工程指示 / 要求簡箋 ENGINEER INSTRUCTIONS (E.I.)

| 工程指示編號: | EI- 4790D | 修改版本: | D |
| 工程編號: | J 853 | 工程名稱: | 大窩坪 (延坪道) |
| 工程項目: | T3 幕牆單元件生產 (大貨) (修訂D:修改Z字碼設計及修改分格呎吋) | 日期: | 29/07/2022 |

| 名稱 | 單元組裝圖 | 制圖 | 付吉寧 | 2022.05.05 | 修改 | A | B | |

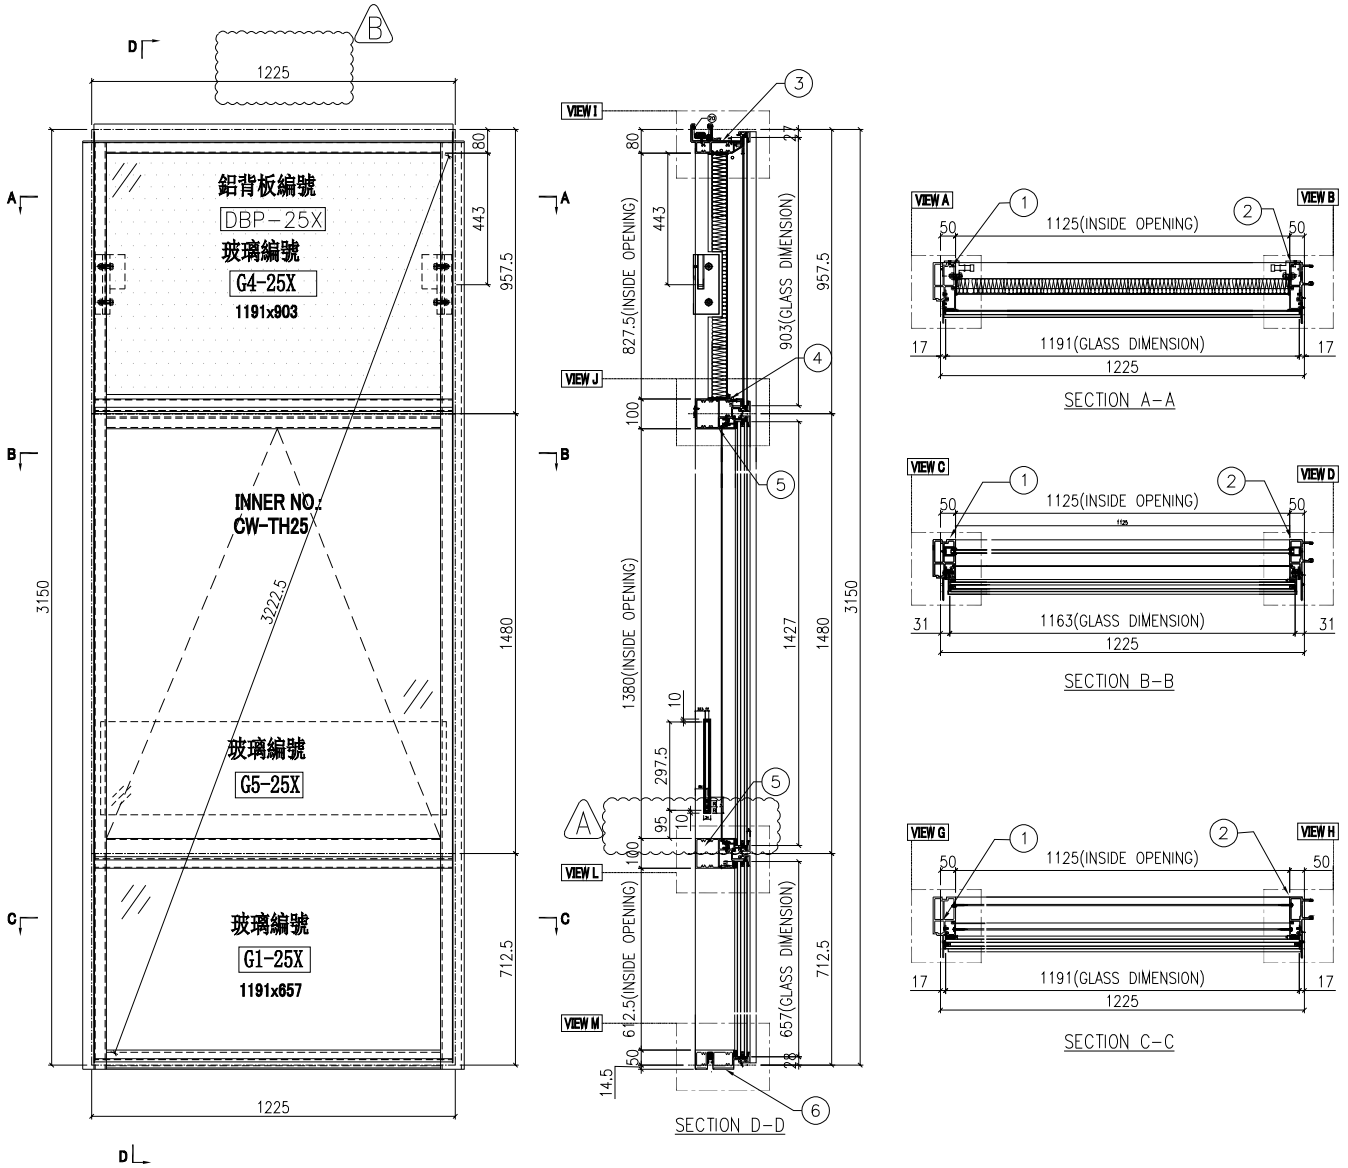
依據E14825修改欄河槽高度

依據E14439-A修改分格寬度, 圖號
原圖號: CW-PTBB25 分格寬度: 1250
更改為: CW-PTBB25X分格寬度: 1225

| 名稱 | 單元組裝圖 | 制圖 | 付吉寧 | 2022.05.05 | 修改 | A | B | |

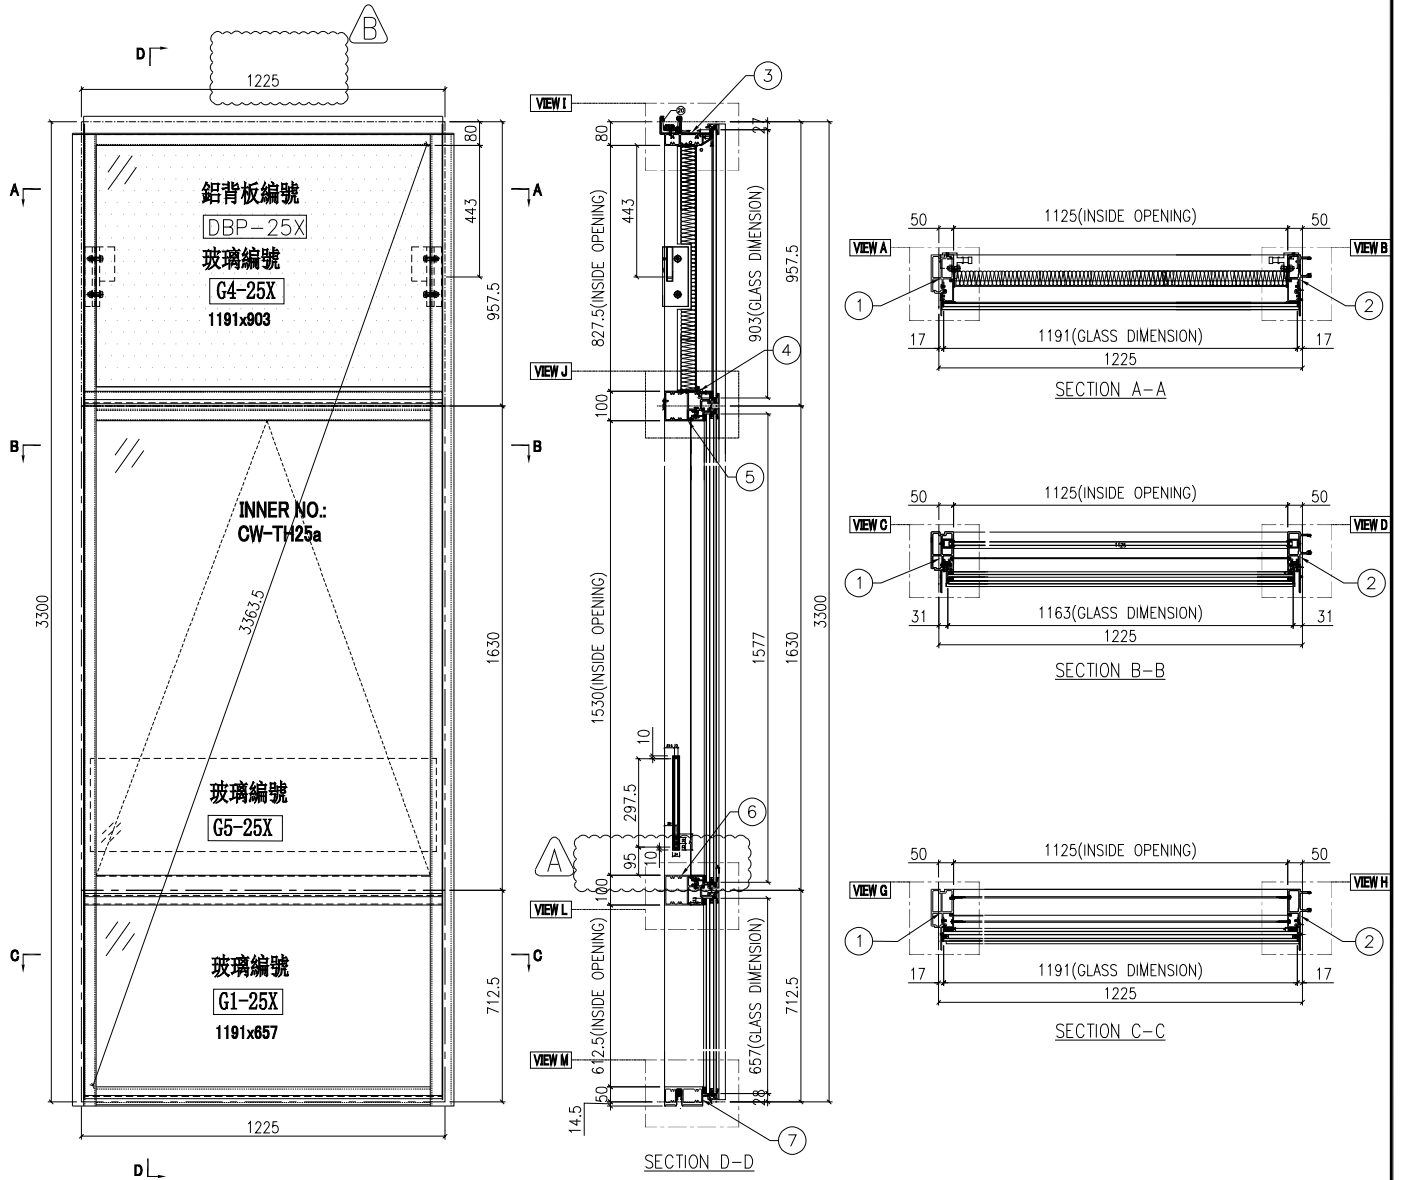
依據E14825 修改攔河槽高度

依據E14439-A 修改分格寬度, 圖號
原圖號: CW-PTBB25a 分格寬度: 1250
更改為: CW-PTBB25aX 分格寬度: 1225

| 名稱 | 單元組裝圖 | 制圖 | 付吉寧 | 2022.05.05 | 修改 | A | B | |

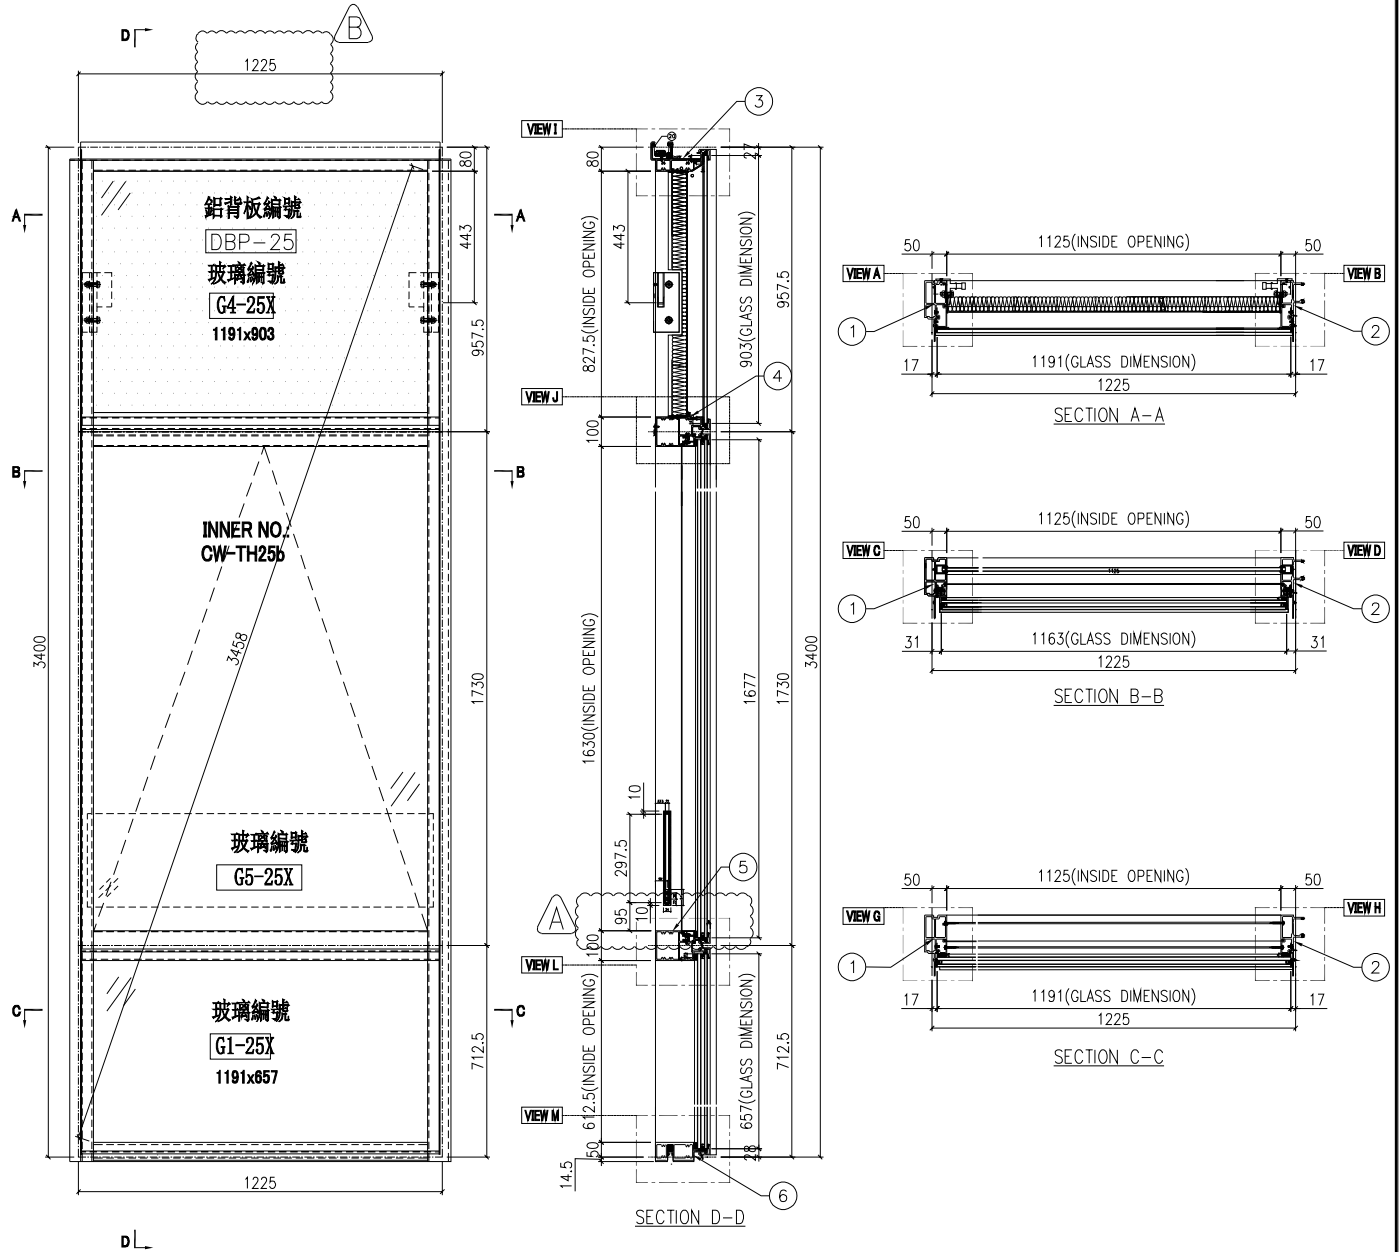
依據E14825 修改欄河槽高度

依據E14439-A 修改分格寬度, 圖號
原圖號: CW-PTBB25b 分格寬度: 1250
更改為: CW-PTBB25bX 分格寬度: 1225

| 名稱 | 單元組裝圖 | 制圖 | 付吉寧 | 2022.05.05 | 修改 | A | | |

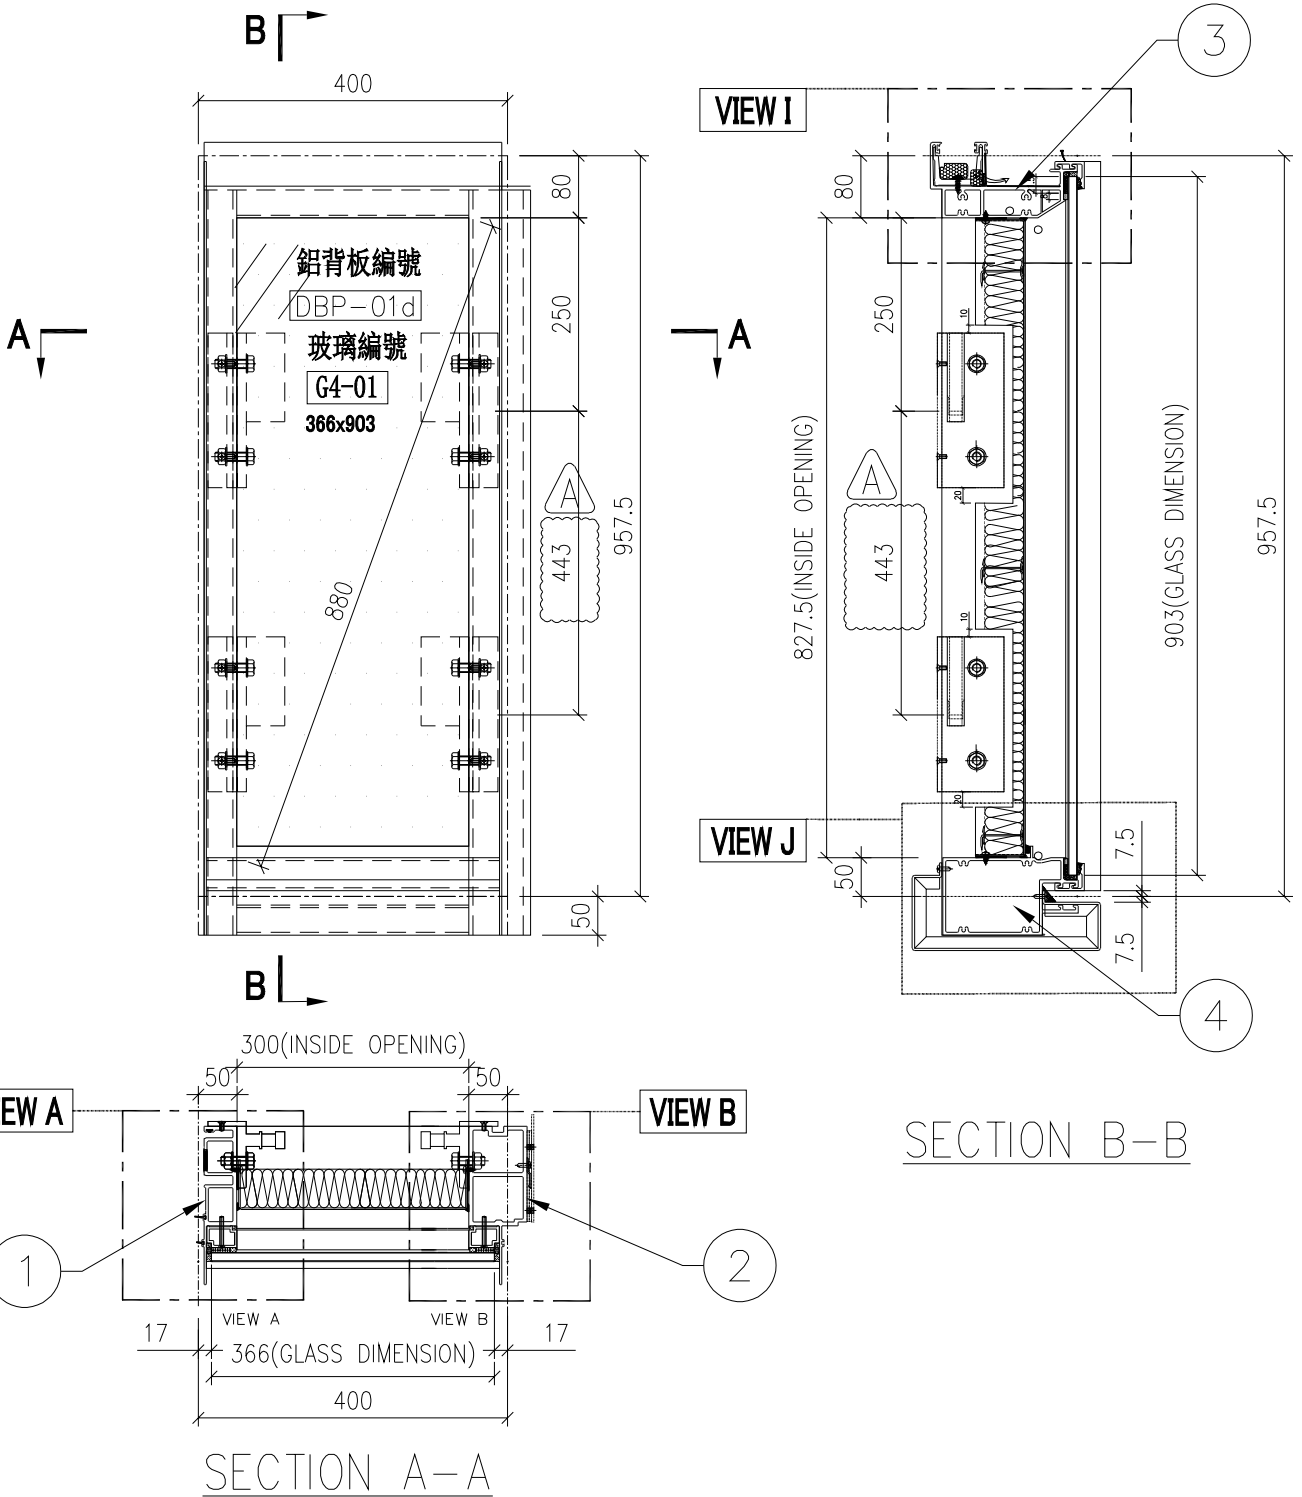
依據E1-4878 修改邊企Z字碼型號
原圖號UN-03-06, 改為UN-01
修改雙掛碼間距

| 名稱 | 梗邊企 | 制圖 | 陳敏聰 | 2022.05.02 | 修改 | A |

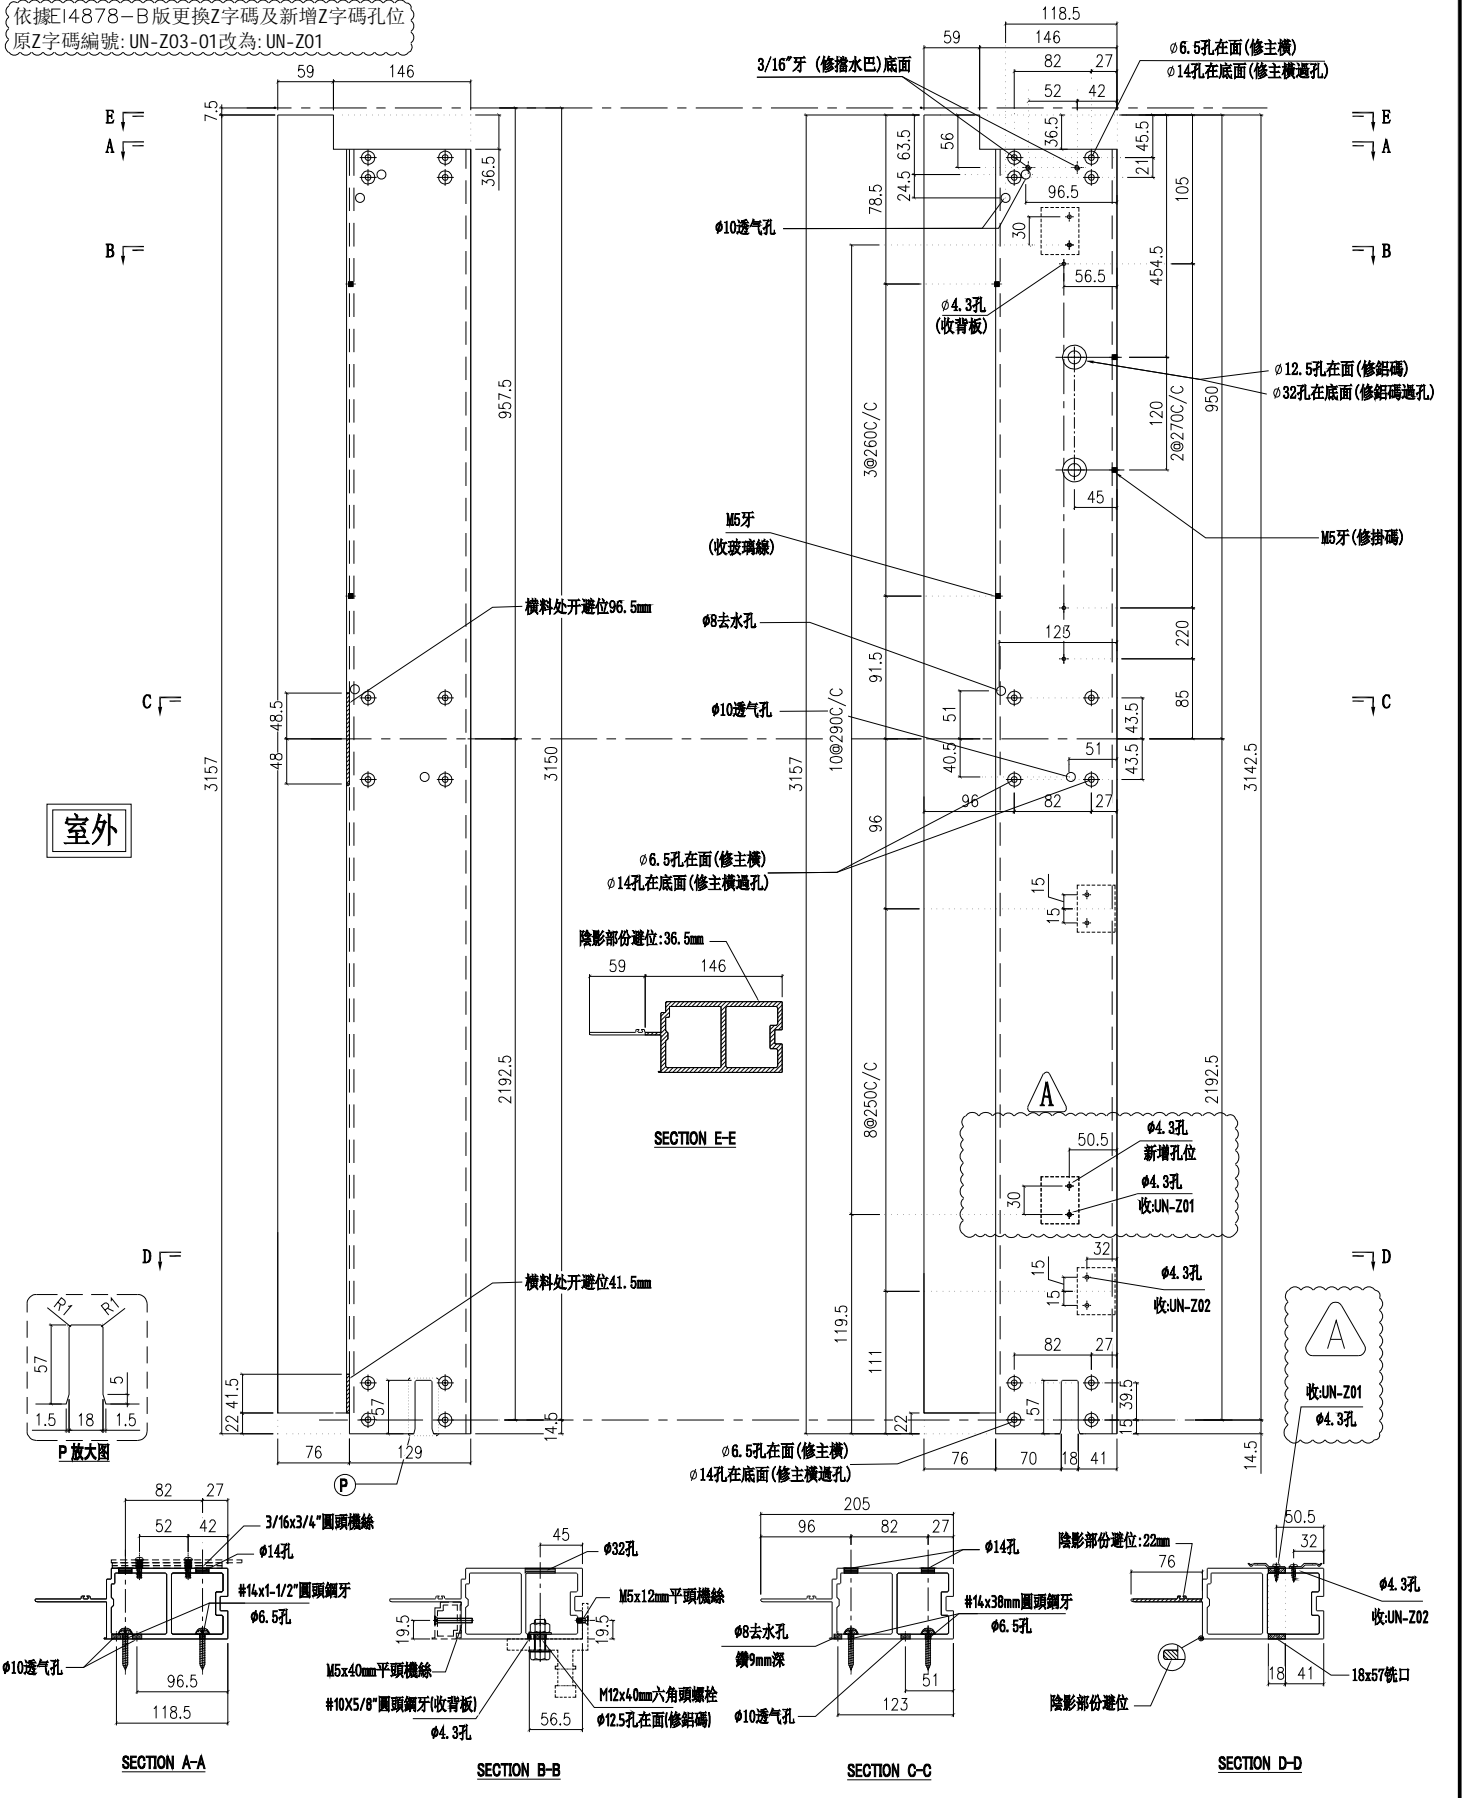
依據E14878-B版更換Z字碼及新增Z字碼孔位
原Z字碼編號: UN-Z03-01改為: UN-Z01
